UNITED STATES PATENT AND TRADEMARK OFFICE

10/810,452

Sehat Sutardja

Office Action Summary

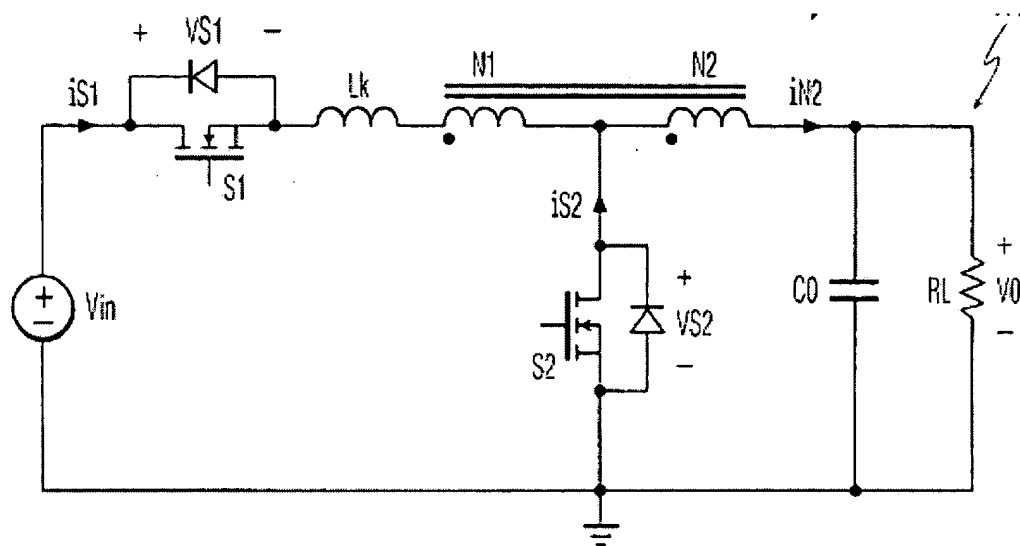
3. Claims 1, 2, 5, 6, 9, 11, 12, 15, 16, 19, 21 and 23 rejected under 35 U.S.C. 102(b) as being clearly anticipated by Qian (USP 6,512,352). Qian discloses the claimed invention a coupled inductor with first, N1, and second, N2, windings connected in series to form a common node, a conduction switch, S1, and a freewheeling switch, S2, the inductor is formed on a single core, and an output capacitor, Co. See figure below.
